## ArevaEPRDCPEm Resource

## Response to

SRP Section: 14.02 - Initial Plant Test Program - Design Certification and New License Applicants

Response to Request for Additional Information No. 313, Supplement 1 U.S. EPR Design Certification Application

14.02-128

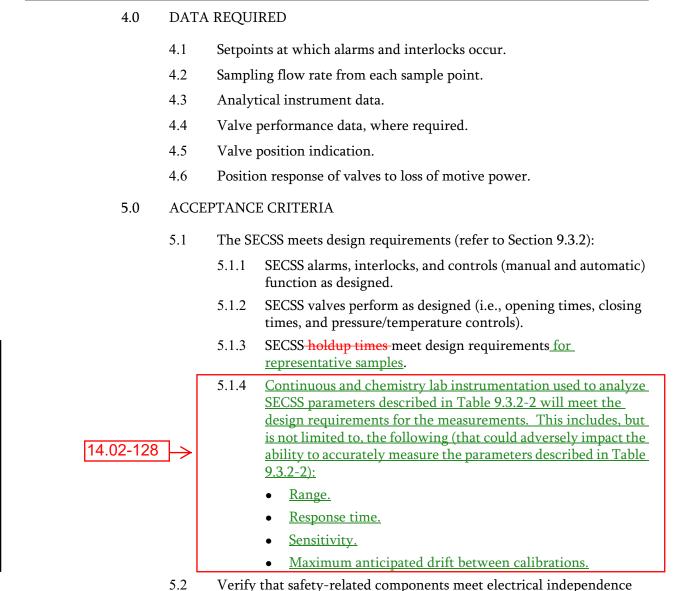
The NRC staff requests that the applicant to revise U.S. EPR FSAR Section 14.2.12.7.13, "Secondary Sampling System (Test #071)," as follows:

- a. Revise prerequisite item 2.3 to state: Calibrating gases and solutions are available for radioactive and non-radioactive analyses as referenced in table 9.3.2-2 of the U.S. EPR FSAR.
- b. Revise the prerequisite section to include an item that requires that all portions of the sampling system be flushed with de-ionized water to ensure that residues of chemical agents used during post-construction cleaning phases have been flushed out.
- c. The acceptance criteria section of test abstract #071 does not define acceptable criteria commensurate with process measurements listed in FSAR section 9.3.2. Therefore, the NRC staff requests that the applicant identify where such acceptance criteria is located in the FSAR, or otherwise revise FSAR Section 9.3.2 accordingly.

- a. U.S. EPR FSAR Tier 2, Section 14.2.12, Test #071 will be revised as follows:
  - 2.4 Calibrating gases and solutions are available for radioactive and non-radioactive analyses as referenced in Table 9.3.2-2.
- b. U.S. EPR FSAR Tier 2, Section 14.2.12, Test #071 will be revised as follows:
  - 2.2 The secondary sampling system has been flushed with demineralized water to remove residues of chemical agents used during construction cleaning phases.
- c. U.S. EPR FSAR Tier 2, Section 14.2.12, Test #071 will be revised to provide acceptance criteria commensurate with process measurements listed in U.S. EPR FSAR Tier 2, Section 9.3.2.

2.2 <u>The secondary sampling system has been flushed with demineralized</u> water to remove residues of chemical agents used during construction cleaning phases.

## 14.2.12.7.14 Steam Generator Blowdown Demineralizing System (Test #072)

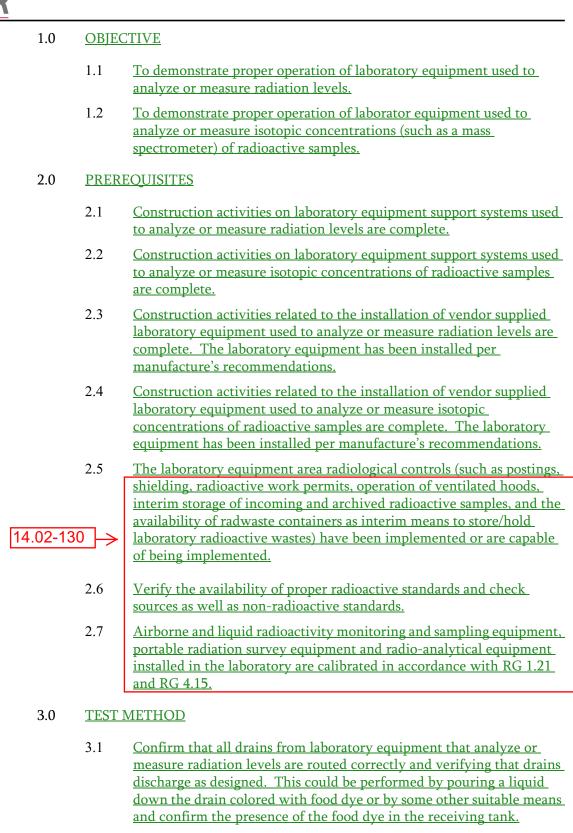
The NRC staff requests that the applicant revise U.S. EPR FSAR Section 14.2.12.7.14, "Steam Generator Blowdown Demineralizing System (Test #072)," as follows:

- Revise prerequisite item 2.3 to state: Calibrating gases and solutions are available for radioactive and non-radioactive analyses as referenced in table 9.3.2-2 of the U.S. EPR FSAR.
- b. Revise the prerequisite section to include an item that ensures the Steam Generator Blowdown System's demineralizers and filters have been loaded with and verified to contain the proper types and amounts of ion exchange resins and filter media.
- c. Revise acceptance criteria item 5.1 to state "The SGB demineralizing system meets design requirements (refer to section 10.4.8, 11.5.4.3 and 11.2)".

- a. U.S. EPR FSAR Tier 2, Section 14.2.12, Test #072 will be revised as follows:
  - 2.3 Calibrating gases and solutions are available for radioactive and non-radioactive analyses as referenced in Table 9.3.2-2.
- b. U.S. EPR FSAR Tier 2, Section 14.2.12, Test #072 will be revised as follows:
  - 2.6 Verify that steam generator blowdown system demineralizers are loaded with the proper type and amount of ion exchange resins.
  - 2.7 Verify that steam generator blowdown system filters are loaded with the proper filter media.
- c. U.S. EPR FSAR Tier 2, Section 14.2.12, Test #072 will be revised as follows:
  - 5.1 The SGB demineralizing system meets design requirements (refer to Sections 10.4.8, 11.2, and 11.5.4.3).

2.5	Secondary sampling system instrumentation has been calibrated and is functional for performance of the following test.
	2.6	<u>Verify that steam generator blowdown system demineralizers are</u> <u>loaded with the proper type and amount of ion exchange resins.</u>

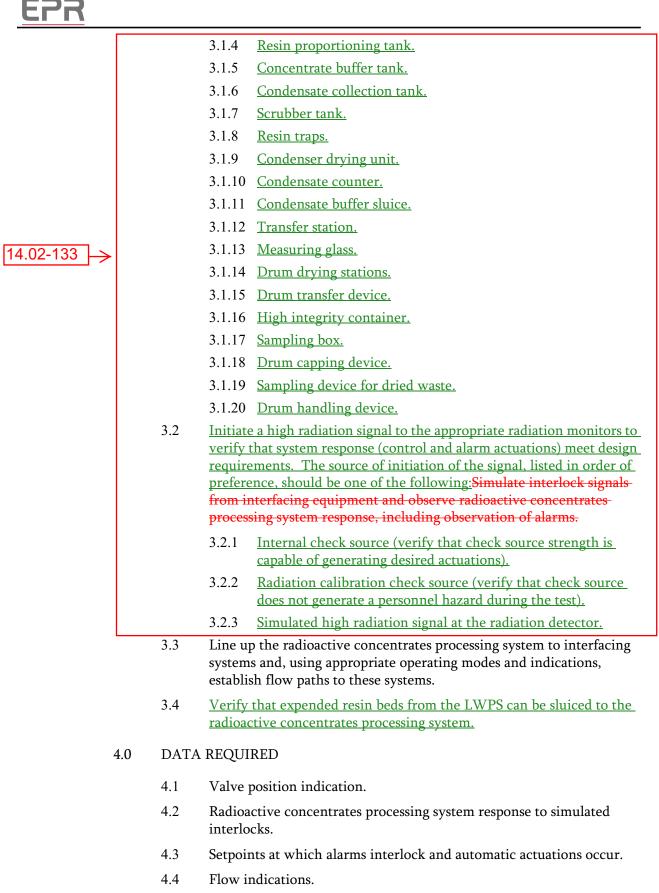
The NRC staff requests that the applicant revise U.S. EPR FSAR Section 14.2.12.9.4, "Radioactive Concentrates Processing System (Test #094)," as follows:

- a. The NRC staff noted that the test method section does not address testing all of the design features of the system, as described in FSAR Section 11.4.2.3.2. The NRC staff requests that the applicant revise the test methods section of test abstract #094 to include testing of all of the components described in U.S. EPR FSAR Section 11.4.2.3.2. Additionally, the staff requests that the applicant include a test method item that verifies the design features of supporting systems (i.e. process ventilation, drainage, and sampling systems).

- b. Revise test method item 3.1 to state: Using radioactive calibration check sources, initiate interlock signals from interfacing equipment and observe radioactive concentrates processing system response, including observation of alarms.

- c. The acceptance criteria section of test abstract #094 does not define acceptable criteria commensurate with process and effluent measurements listed in FSAR Sections 11.5, 11.2.2 and 11.4. Therefore, the NRC staff requests that the applicant identify where such acceptance criteria are located in the FSAR, or otherwise revise FSAR Sections 11.5, 11.2.2 and 11.4 accordingly.

- a. U.S. EPR FSAR Tier 2, Section 14.2.12, Test #094 will be revised to include the subsystems described in U.S. EPR FSAR Tier 2, Section 11.4.2.3.2.
- b. U.S. EPR FSAR Tier 2, Section 14.2.12, Test #094 will be revised to provide guidance for generating a high radiation signal to verify system response (control and alarm actuation).
- c. U.S. EPR FSAR Tier 2, Section 14.2.12, Test #094 will be revised to provide acceptance criteria for process and effluent measurements listed in U.S. EPR FSAR Tier 2, Table 11.5-1.

- 5.1 The radioactive concentrates processing system performs as described in Sections 11.2.2-and , 11.4, and 11.5.
- 5.2 <u>Radiation monitoring instrumentation used to monitor the radioactive</u> <u>concentrations activity prior to entry of the solid radwaste system that</u> <u>is described in Table 11.5-1 will meet the design requirements for the</u> <u>radiation monitor. This includes, but is not limited to, the following</u> <u>(that could adversely impact the ability to measure the parameters</u> <u>described in Table 11.5-1):</u>
  - 5.2.1 <u>Range.</u>
  - 5.2.2 <u>Response time.</u>
  - 5.2.3 <u>Sensitivity.</u>
  - 5.2.4 <u>Maximum anticipated drift between calibrations.</u>

14.02-134

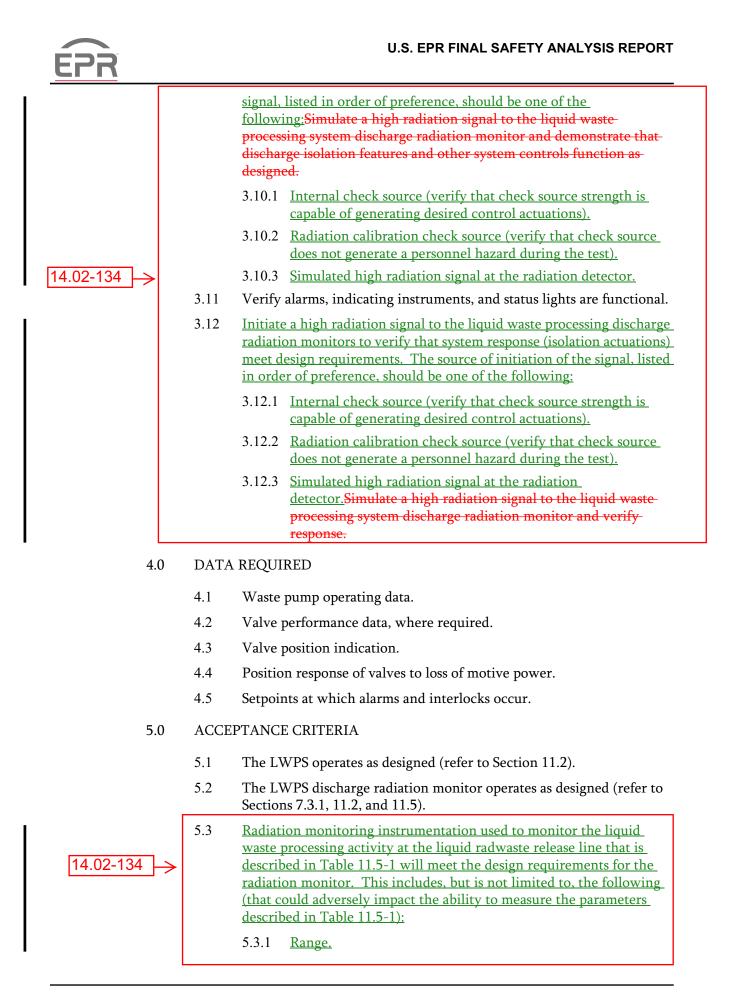
The NRC staff requests that the applicant revise U.S. EPR FSAR Section 14.2.12.9.5, "Liquid Waste Processing System (Test #095)," as follows:

- a. Revise the prerequisite section to include an item that ensures the Liquid Waste Processing System's demineralizers and ultra filtration system have been loaded with and verified to contain the proper types and amounts of ion exchange resins and filtration media.

- b. The NRC staff noted that the test method section does not address testing all of the design features of the system, as described in FSAR Section 11.2.2.4.2. The NRC staff requests that the applicant revise the test methods section of test abstract #095 to include testing of all of the components described in U.S. EPR FSAR Section 11.2.2.4.2.

- c. Revise test method item 3.7 to state: Using radioactive calibration check sources, initiate a high radiation signal to the liquid waste processing system discharge radiation monitor and demonstrate that discharge isolation features and other system controls function as designed.

- d. Revise test method item 3.9 to state: Using radioactive calibration check sources, initiate a high radiation signal to the liquid waste processing system discharge radiation monitor and verify response.

- e. The acceptance criteria section of test abstract #095 does not define acceptable criteria commensurate with process measurements listed in FSAR Sections 11.2 and 11.5. Therefore, the NRC staff requests that the applicant identify where such acceptance criteria is located in the FSAR, or otherwise revise FSAR Sections 11.2 and 11.5 accordingly.

- a. U.S. EPR FSAR Tier 2, Section 14.2.12, Test #095 will be revised as follows:
  - 2.2 Verify that the liquid waste processing system's demineralizers and ultra filtration are loaded with the proper types and amounts of ion exchange resins and filtration media.

- b. U.S. EPR FSAR Tier 2, Section 14.2.12, Test #095 will be revised to include the subsystems described in U.S. EPR FSAR Tier 2, Section 11.2.2.4.2.1, Section 11.2.2.4.2.2, and Section 11.2.2.4.2.3.

- c. U.S. EPR FSAR Tier 2, Section 14.2.12, Test #095 will be revised to provide guidance for generating a radiation signal to verify system response (control and alarm actuation).

- d. U.S. EPR FSAR Tier 2, Section 14.2.12, Test #095 will be revised to provide guidance for generating a high radiation signal to verify system response (isolation actuation).

- e. U.S. EPR FSAR Tier 2, Section 14.2.12, Test #095 will be revised to provide acceptance criteria for process measurements listed in U.S. EPR FSAR Tier 2, Table 11.5-1.

- 2.2 <u>Verify that the liquid waste processing system's demineralizers and</u> <u>ultra filtration are loaded with the proper types and amounts of ion</u> <u>exchange resins and filtration media.</u>
- 2.3 Liquid waste processing system instrumentation has been calibrated and is operating satisfactorily prior to performing the following test.
- 2.4 Support systems required for operation of the liquid waste processing system are completed and functional.
- 2.5 Test instrumentation is available and calibrated.

#### 14.2.12.9.9 Gaseous Waste Processing System (Test #099)

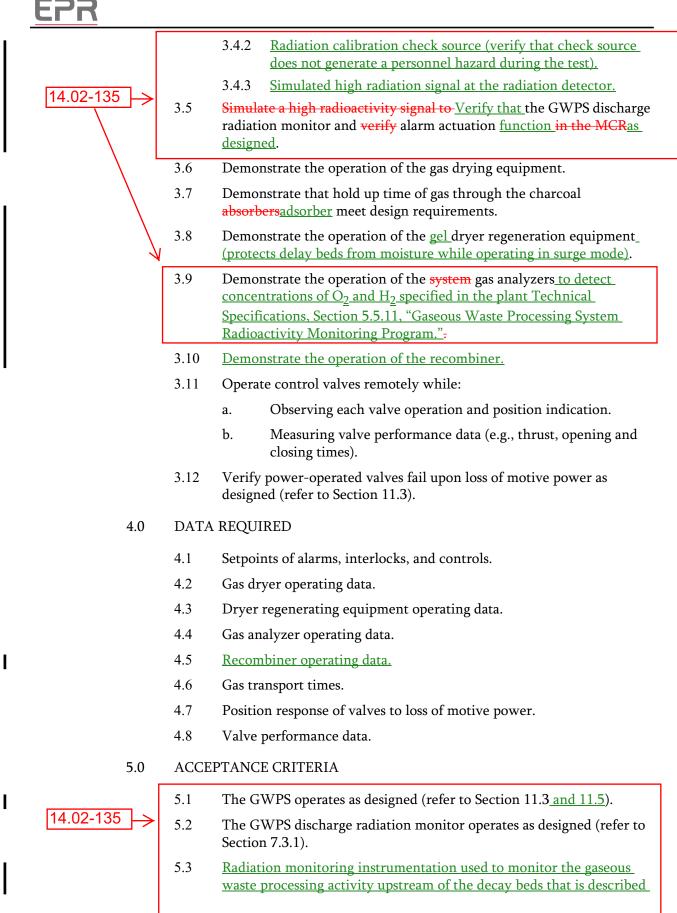
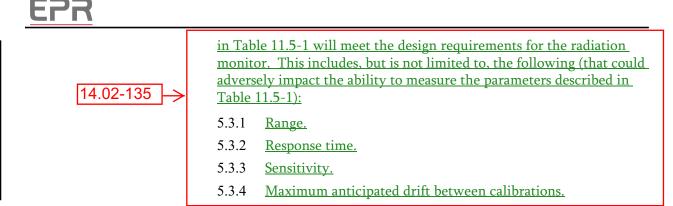
The NRC staff requests that the applicant revise U.S. EPR FSAR Section 14.2.12.9.9, "Gaseous Waste Processing System (Test #099)," as follows:

- a. Revise the prerequisite section to include an item that ensures the Gaseous Waste Processing System's charcoal beds and gel driers have been loaded with and verified to contain the proper types and amounts of charcoal and desiccant.

- b. Revise test method item 3.3 to state: Using radioactive calibration check sources, initiate a high radiation signal to the GWPS discharge radiation monitor.

- c. Revise test method item 3.5 to state: Using radioactive calibration check sources, initiate a high radiation signal to the GWPS discharge radiation monitor and verify alarm actuation as designed.

- d. Revise test method item 3.9 to state: Demonstrate the operation of the gas analyzers to detect O<sub>2</sub> and H<sub>2</sub> in concentrations ranges as specified by plant technical specification.

- e. The acceptance criteria section of test abstract #099 does not define acceptable criteria commensurate with process measurements listed in FSAR Sections 11.5 and 11.3. Therefore, the NRC staff requests that the applicant identify where such acceptance criteria is located in the FSAR, or otherwise revise FSAR Sections 11.5 and 11.3.

- a. U.S. EPR FSAR Tier 2, Section 14.2.12, Test #099 will be revised as follows:
  - 2.5 Verify that the GWPS charcoal beds and gel driers are loaded with the proper types and amounts of charcoal and desiccant.

- b. U.S. EPR FSAR Tier 2, Section 14.2.12, Test #099 will be revised to provide guidance for generating a high radiation signal to verify system response (control and alarm actuation).

- c. U.S. EPR FSAR Tier 2, Section 14.2.12, Test #099 will be revised as follows:
  - 3.5 Verify that the GWPS discharge radiation monitor and alarm actuation function as designed.

- d. U.S. EPR FSAR Tier 2, Section 14.2.12, Test #099 will be revised as follows:
  - 3.9 Demonstrate the operation of the gas analyzers to detect concentrations of O<sub>2</sub> and H<sub>2</sub> specified in the plant Technical Specifications, Section 5.5.11, "Gaseous Waste Processing System Radioactivity Monitoring Program."

- e. U.S. EPR FSAR Tier 2, Section 14.2.12, Test #099 will be revised to provide acceptance criteria for process measurements listed in U.S. EPR FSAR Tier 2, Table 11.5-1.

- 2.5 <u>Verify that the GWPS charcoal beds and gel driers are loaded with the</u> proper types and amounts of charcoal and desiccant.
- 3.0 TEST METHOD
  - 3.1 Verify flow paths.
  - 3.2 Demonstrate that discharge isolation features and other system controls function as designed.
  - **3.3** Simulate a high radiation signal to the GWPS discharge radiation monitor.

#### 14.2.12.18.5 Sampling Primary and Secondary Systems (Test #204)

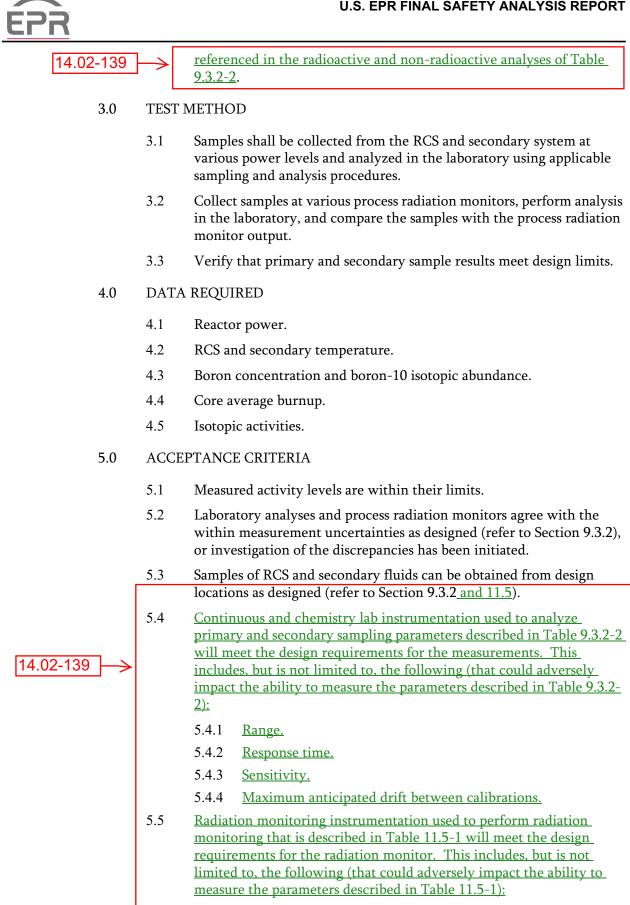
The NRC staff requests that the applicant revise U.S. EPR FSAR Section 14.2.12.12.5, "Sampling Primary and Secondary Systems (Test #204)," as follows:

- a. Revise prerequisite item 2.2 to state: Required sampling systems are functional and analysis instrumentation are calibrated using calibration gases and solutions as referenced in the radioactive and non-radioactive analyses of table 9.3.2-2 of the U.S. EPR FSAR.
- b. The acceptance criteria section of test abstract #204 does not define acceptable criteria commensurate with process measurements listed in FSAR Section 9.3.2. Therefore, the NRC staff requests that the applicant identify where such acceptance criteria is located in the FSAR, or otherwise revise FSAR Section 9.3.2 accordingly.

- a. U.S. EPR FSAR Tier 2, Section 14.2.12, Test #204 will be revised as follows:
  - 2.2 Required sampling systems are functional and analysis instrumentation are calibrated using calibration gases and solutions as referenced in the radioactive and non-radioactive analyses of Table 9.3.2-2.
- b. U.S. EPR FSAR Tier 2, Section 14.2.12, Test #204 will be revised to provide acceptance criteria for process measurements listed in U.S. EPR FSAR Tier 2, Table 9.3.2-2 and U.S. EPR FSAR Tier 2, Table 11.5-1.

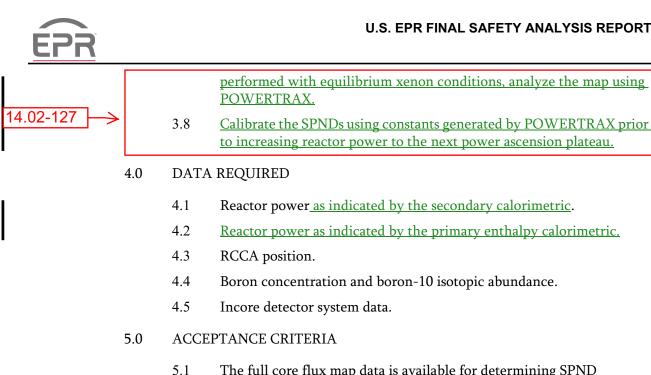
In AREVA's response to RAI #150 (ML091350078) question 12.03-12.04-4, the applicant stated the following about the Aeroball Measurement System (AMS):

U.S. EPR FSAR Tier 2, Section 14.2.12, Test #206 is the appropriate test to perform the saturation activation of the AMS ball stacks that was described in the Response to RAI 150, Supplement 1, Question 12.03-12.04-4. U.S. EPR FSAR Tier 2, Section 14.2.12, Test #206 will be revised to include a normal sequence reading of the activated AMS ball stacks and a reverse order reading of the AMS ball stacks to establish time dependence and decay constants of material components.

U.S. EPR FSAR Tier 2, Section 14.2.12, Test #206 will be revised as described in the response and indicated on the enclosed markup.
